# Access Compliance Report

## Public Rights-of-Way

Intersection ID: 9996	Main Street: BARRINGTON_DR	Cross Street: WOODY_GLEN_PL	Location: NW
ADA ID: C920E8AB52C0	Ramp Type: Directional1	Initial Pass/Fail: Fail	Overall Compliance: No
		Severity Score: 25

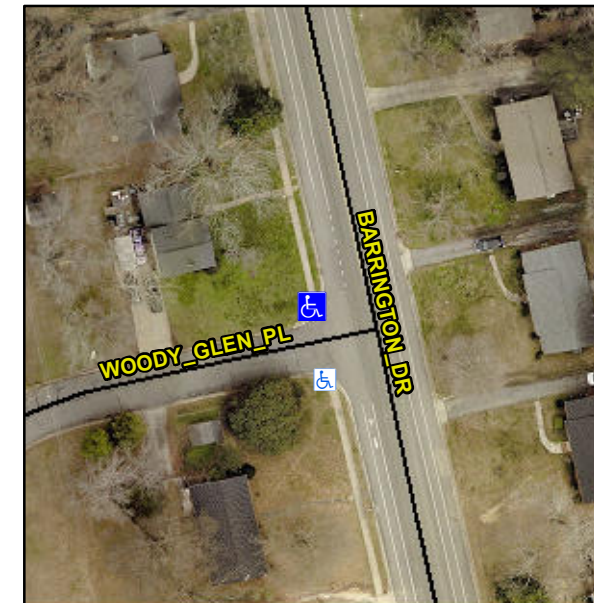
**R304.2.2**

Compliance	Description	Data	Compliance	Description	Data
N/A	Ramp Length (in)	66.5	N/A	Grade Break?	N/A
Yes	Ramp Width (in)	48.0	N/A	Grade Break Slope (%)	0.0
No	Ramp Slope (%)	13.5	N/A	Grade Break XSlope (%)	0.0
Yes	Ramp XSlope (%)	0.4			
N/A	Flare Type LT	N/A	N/A	Flare Type RT	N/A
N/A	Flare Slope LT (%)	N/A	N/A	Flare Slope RT (%)	0.0
N/A	Flare Traversable LT?	N/A	N/A	Flare Traversable RT?	N/A
N/A	Landing Length (in)	0.0	N/A	DWS Provided?	N/A
N/A	Landing Width (in)	0.0	N/A	DWS Contrast?	N/A
N/A	Landing Slope (%)	0.0	N/A	DWS Length (in)	N/A
N/A	Landing X Slope (%)	0.0	N/A	DWS Full Width?	N/A
N/A	Landing Curb? (Y/N)	N/A	N/A	DWS Offset LT (in)	N/A
N/A	Shared Landing?	N/A	N/A	DWS Offset RT (in)	N/A
N/A	Gutter Ponding?	0.0	N/A	Gutter Slope (%)	N/A
N/A	Gutter Lip Ht (in)	0.0	N/A	Gutter X Slope (%)	N/A
N/A	Painted X Walk1?	No		Road Slope (%)	3.5
	X Walk 1 Direction	To SE		Road X Slope (%)	3.1
	X Walk 1 Width (in)	N/A		Clear Space?	N/A

**Remove & Replace Entire Ramp.**
